GUIDE PAGE - REPORT TES-3209

This is the Guide Page to update report TES-3209 to Revision 2, December 1991.

**RESUBMITTAL OF PRIOR APPLICATIONS
AND SUPPLEMENTS FOR APPROVAL TO
TRANSPORT THE SENTINEL-25B
RADIOISOTOPE THERMOELECTRIC GENERATOR
AS A TYPE B () PACKAGE**

TES-3209

FIGURE E-1. SENTINEL 25B GENERATOR/SHIPPING PALLET MOUNTING HARDWARE

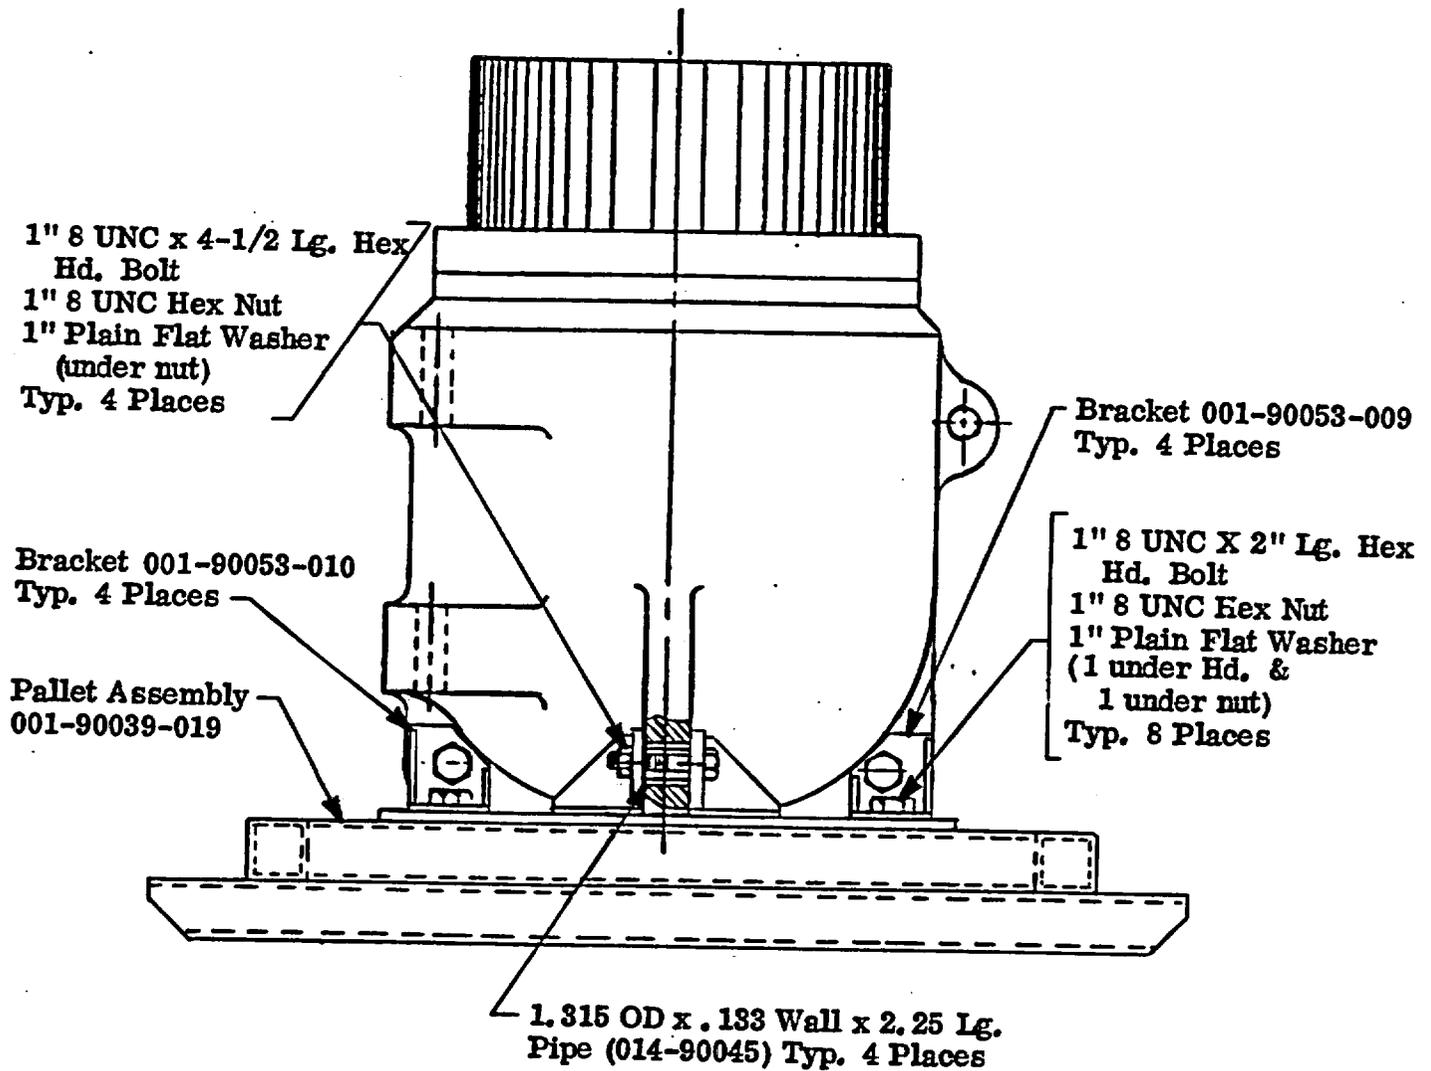
- a. Insure that the finned radiator assembly is bolted to the RTG's lid. (It should not normally ever be removed.)
- b. Insure that the "shorting plug" furnished with the RTG is installed, when the RTG is disconnected from its electrical load.
- c. Insure that the RTG is properly installed on its steel shipping pallet and the attaching hardware shown in Figure E-1 is torqued to 120-130 foot-pounds.

The hardware that attaches the RTG to its shipping pallet (see Figure E-1) should be inspected prior to each shipment for signs of corrosion, structural damage and other forms of deterioration. The hardware must be replaced with new hardware if structural integrity is in doubt.

FIGURE E-2. PALLET TIE-DOWN CONFIGURATION

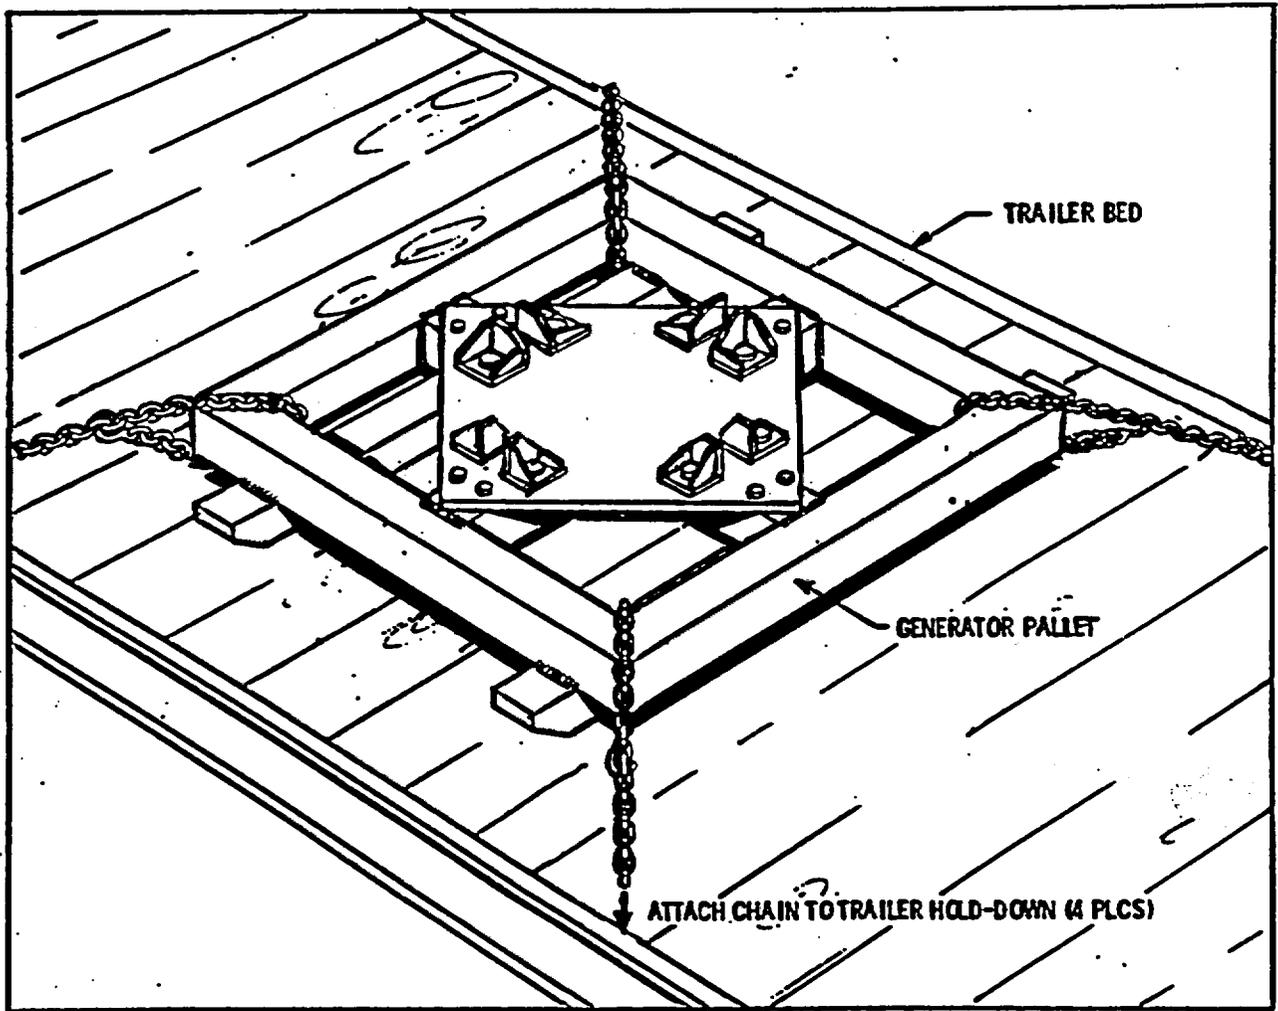
The RTG, when loaded for shipment is to be tied down in a configuration similar to that shown in Figure E-2. In addition, the RTG must not be covered and should be kept at least one foot from bulkheads, other cargo and any other obstructions which might restrict the flow of air around the generator.
